Lahontan Regional Water Quality Control Board

Conditional Acceptance of Interim Revised Draft Off-Site Remedial Action Plan, Regional PCE Contamination, August 2026, Lake Tahoe Laundry Works, 1024 Lake Tahoe Boulevard, South Lake Tahoe, El Dorado County, Site Cleanup Program Case #T6S043, Geotracker Global ID SL0601754315

Figure 7-1. LBWC No. 5 performance monitoring annual compliance cycle (criterion).

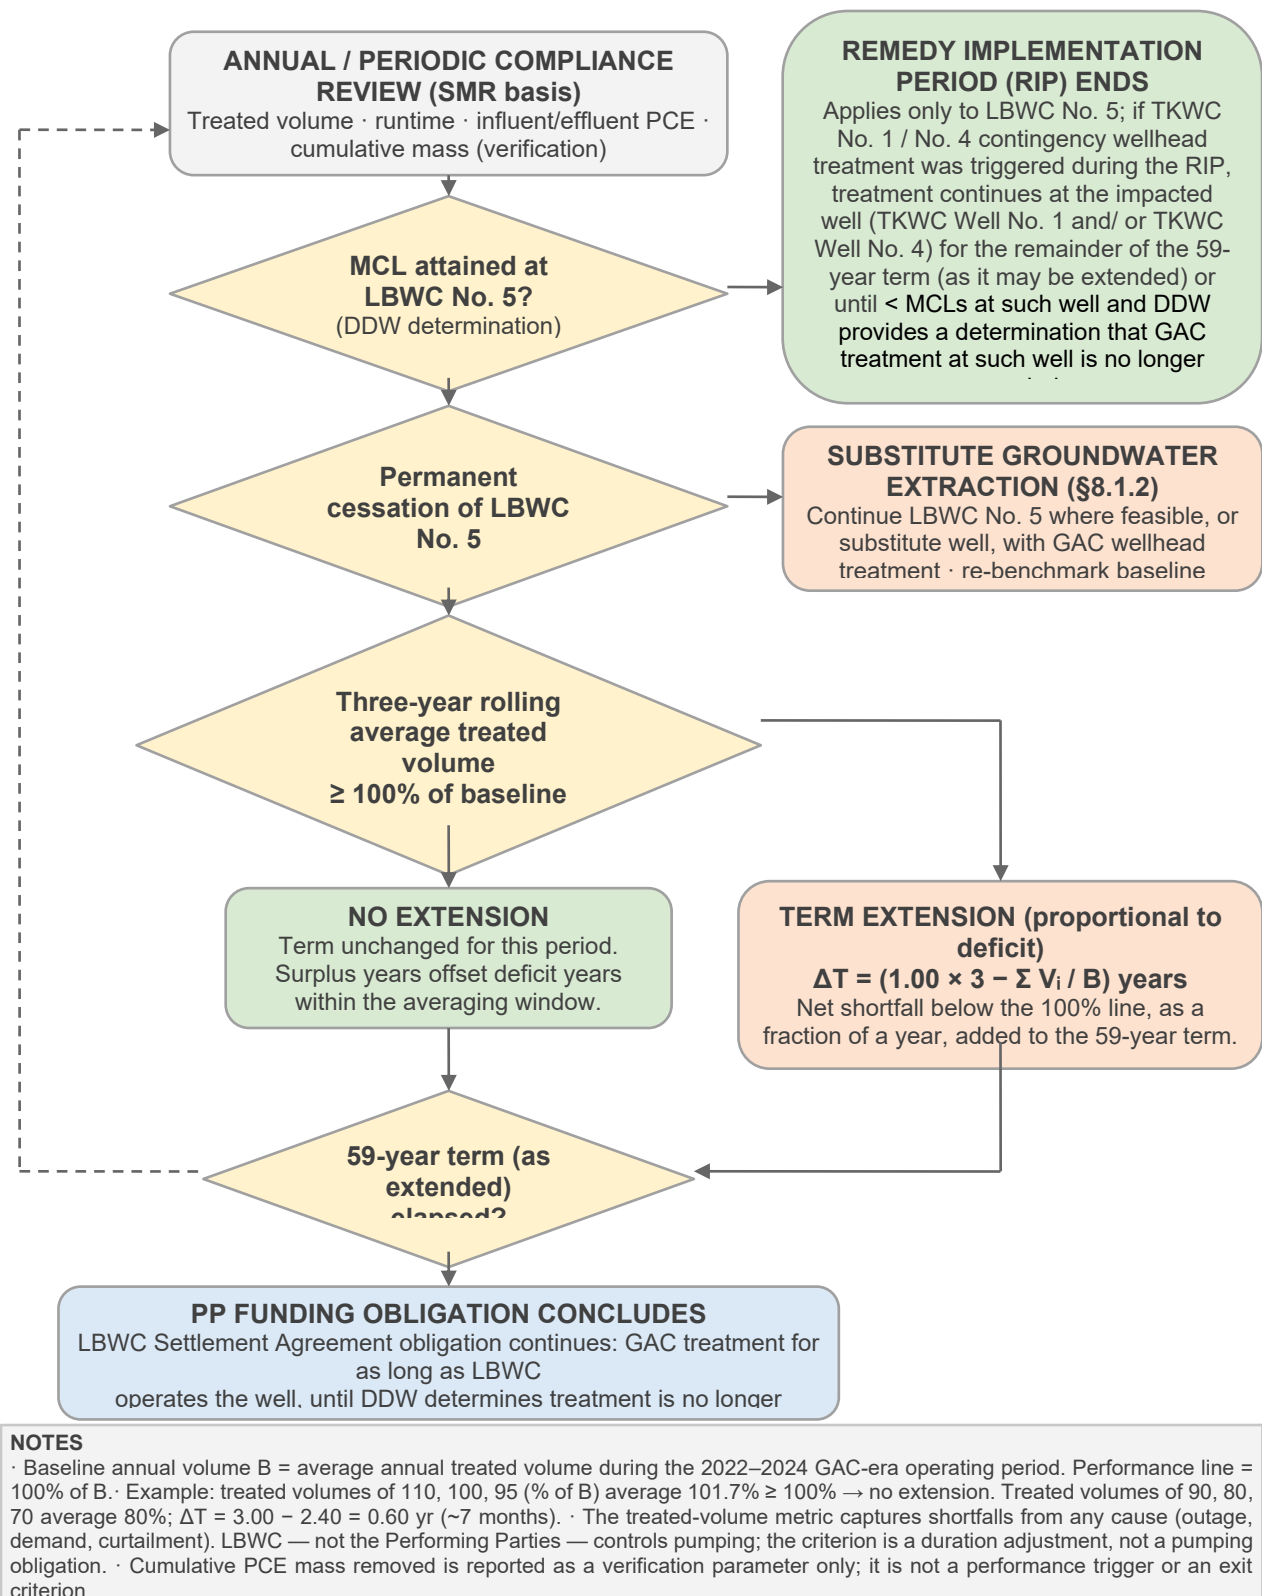
Figure 7.1 was inadvertently omitted from the OSRAP. The figure is included as Enclosure 1 to this letter and is deemed revised to indicate the periodic compliance review cycles needed to evaluate Section 7.5.2 performance criterion and calculate extension to the 59-year timeframe if the Section 7.5.2 performance criterion is not met.
